CLASS ENVIRONMENTAL ASSESSMENT UPDATE TECHNICAL MEMORANDUM

Re: **Coronation Park Drainage Improvements Class Environmental Assessment
EA Update – Technical Memorandum, Town of Oakville**

**Re: Coronation Park Drainage Improvements
Municipal Class Environmental Assessment Study
Notice of Study Commencement
Town of Oakville
Our File: MPR 662**

Figure 1: Shingle/Barrier Beaches, Halton Lake Ontario Shoreline

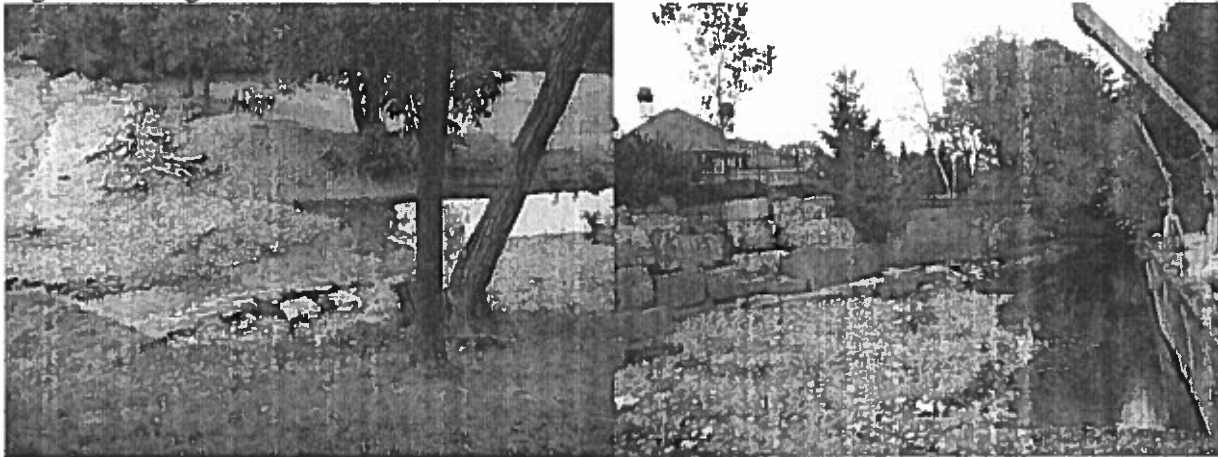
- Staff request more information about the concerns related to 'blockage of watercourses at Lake Ontario due to material washing onshore'. Conservation Halton recommends that the connections with the lake remain protected by the existing and natural accumulation of the shingle/barrier beaches. These natural lacustrine features are an effective and environmentally friendly protection of the shoreline against erosion hazards and serve a number of ecological functions. Barrier beaches can be found throughout the Halton shoreline, as shown in the photos below (Figure 1). Any structural shoreline protection measures are usually not effective and may negatively impact natural coastal processes along

the shoreline. An annual maintenance plan should be developed to keep entrances open to sustain the flows.

- Watercourse/shoreline modification by humans via hardening measures such as concrete, armour stone, wood or steel walls and the removal of vegetation around lakes and stream banks negatively alter natural shoreline processes. Removal of vegetation decreases the stability of the bank and increases shoreline erosion. A goal of both the Oakville Harbour West Shore Master Plan and Tannery and Waterworks Parks EA (nearby similar Town initiatives) is to use a variety of plant materials that will provide diversity, and will be reminiscent of native plant material found along the water's edge. Part of CH's mandate is to promote restoration using native, non-rare plant species throughout its watershed, predominantly in areas regulated by our own regulation (Ontario Regulation 162/06). The opportunity to see this goal come to fruition within the Coronation Park Community is tremendous. Staff feel that restoration such as this has the potential to demonstrate our joint commitment to the natural environment to residents, tourists and other park users, and to educate the public and further the potential for shoreline naturalization. We look forward to working together to re-establish the flora of the shoreline and hydrologic features in this area.
